SODIUM PENTABORATE TANK, VOLUME VS. CONCENTRATION REQUIREMENTS

FIGURE 3.1.5-2

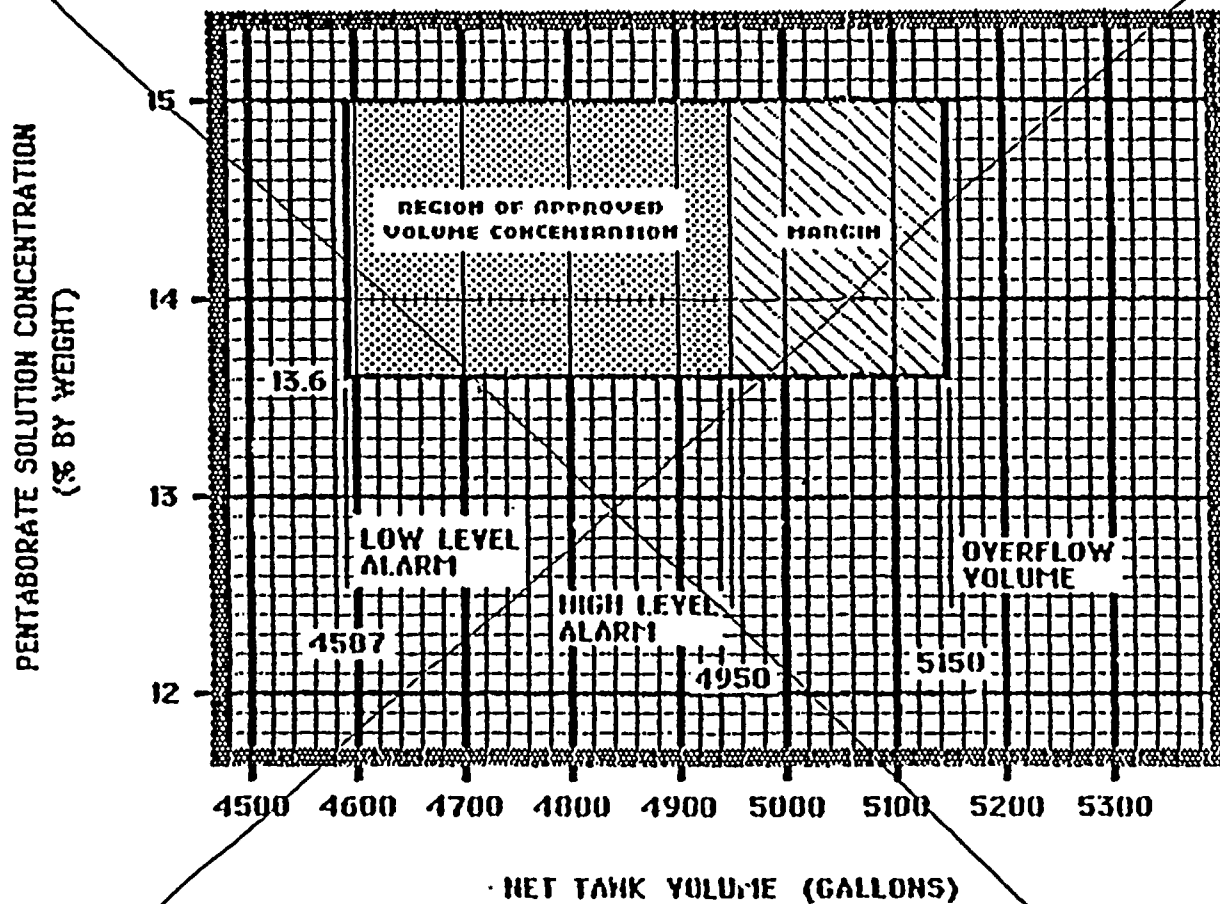
Replace with redrawn graph
